Brussels, 9 October 2019

## Air conditioners and comfort fans: Position on the Ecodesign & Energy Labelling proposals

Following the Consultation Forum meeting which took place on 9 September 2019 to discuss the revision of the Ecodesign and Energy Labelling regulations on air conditioners and comfort fans, we call upon the European Commission to take the present paper into consideration.

**Figure 1.** Topten: Distribution of noise value for indoor and outdoor units according to their cooling capacity

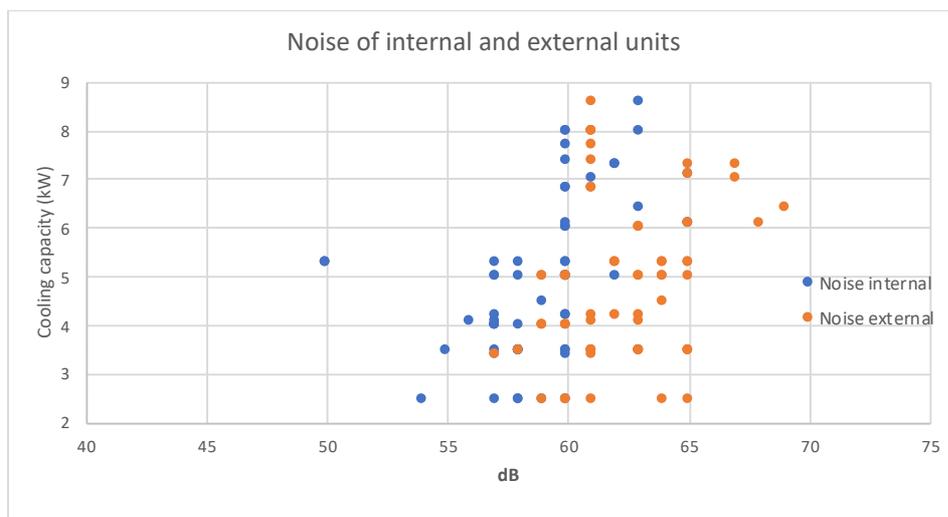
Topten data (see Figure 1) shows that already today there are units that widely surpass the proposed ecodesign requirements.

Therefore, we believe that the maximum sound power requirements should be more ambitious and changed accordingly. See our proposal below:

Topten data (see Figure 1) shows that indoor units are significantly less noisy than outdoor units. It also shows that larger capacities tend to be noisier, but the correlation is very weak because the data is very dispersed. Furthermore, the proposed classes show that class A would be empty and class B would be almost empty while leaving most indoor and outdoor units in classes C and D. Thus we believe that by keeping separate scales for the classes of indoor and outdoor units would allow for better product differentiation by optimising the use of all the four classes. Here is our proposal:

Cooling capacity	Sound power level in dB(A)					
	Current regulation		Proposal in the working document		Proposal for new levels	
	Indoor	Outdoor	Indoor	Outdoor	Indoor	Outdoor
Split units < 6KW	60	65	60	65	57	60
Split units ≥ 6KW	65	70	65	70	60	63
